Service Bulletin

APRIL

NO. 346

*Studebaker and
Packard*

FIG. 1

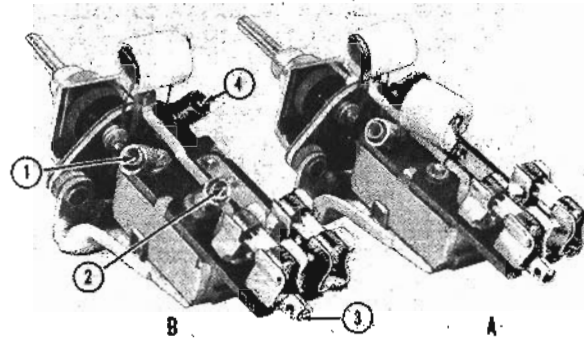
A new Climatizer switch has been released for the 1956 Studebaker passenger cars. This switch with a separate resistor will provide longer life for the switch in instances where the Climatizer blower motor has tendency to stick. However, it will not assure satisfactory heater performance unless the blower motor is in good operating condition.

1. Remove the present combination heater and defroster switch (Part No. 1540151) Type A shown in Fig. 1. Install the new switch, Type B in Fig. 1. Connect the yellow heater motor wire to the #1 terminal. (Fig. 1). Connect the added red wire 'F' (48" long) to #2 terminal. Connect the switch feed wire to the #3 terminal and the defroster wire to the #4 terminal.

FIG. 2

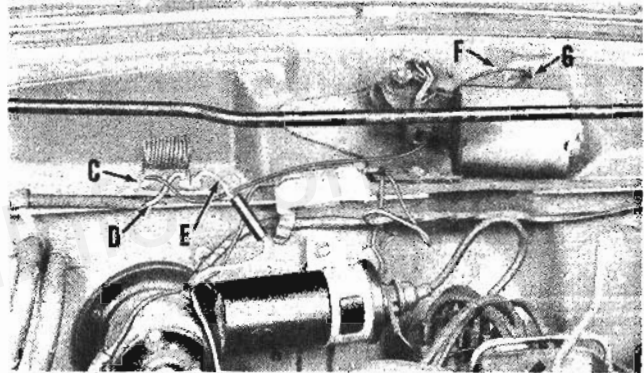
3. Mount the retainer on the dash flange using 2 screws in the location shown on Fig. 2. The inner mounting hole should be 3" to the right of the ignition primary resistor mounting screw hole. The front edge of the heater resistor bracket should be flush with the front edge of the dash flange. Drill a 5/32" diameter hole for the screws furnished in the kit.

4. Connect the heater motor wire 'D' to one of the double terminal receptables of the heater resistor. Using the 3" yellow wire (from kit) 'E' connect the yellow wire of the chassis cable to the other receptacle of the double terminal. Wire 'F' connects to the single receptacle of the heater motor resistor at 'C'.

FIG. 3

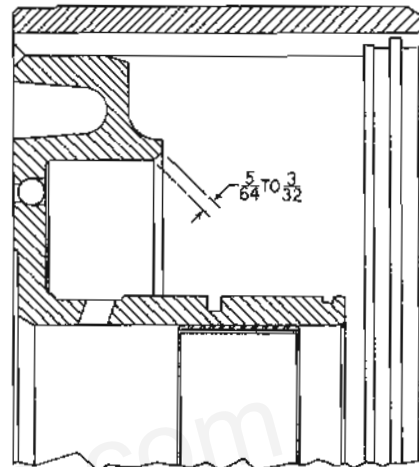
It has been brought to our attention that some difficulty has been experienced in installing the clutch operating piston in the high range clutch housing which resulted in

damage to the piston rubber seal. Investigation has shown that this problem may be encountered if the chamfer at the top of the piston bore is too narrow. The correct width of the chamfer when measured across the diagonal face of the chamfer should be 5/64" to 3/32" (See Fig. 3).

Housings having less than 5/64" chamfer may be returned to the Parts Depot in exchange for a housing with the chamfer within the specification.
